Index 700-102 Special Sign Details

FY 2025-26
 STANDARD PLANS

SPECIAL SIGN DETAILS

INDEX
 700-102

FTP-68A-06
 9" X 1'-3"
 1.5" Radii 3/4" Border Series B Legend
 White Background Black Legend and Border

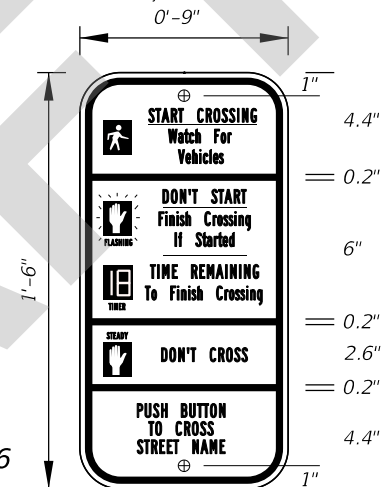
The depictions of FTP-68A-06 and FTP-68B-06 are being updated to more closely depict R10-3f and R10-3i in the MUTCD 11th Edition.

Deleting FTP-68B-06 from Index 700-102 is a terrible mistake. This design is very frequently used in our district's signalization plans and there is nothing in the new MUTCD that sufficiently replaces it. We need the flexibility to use pedestrian detector signs which do not include directional arrows.

We will add FTP-68A-06 and FTP-68B-06 back in with it updated to more closely align with the MUTCD 11th edition.

CHANGE MADE TO INDEX: Yes, FTP-86A-06 and FTP-86B-06 were added back into the index and updated.
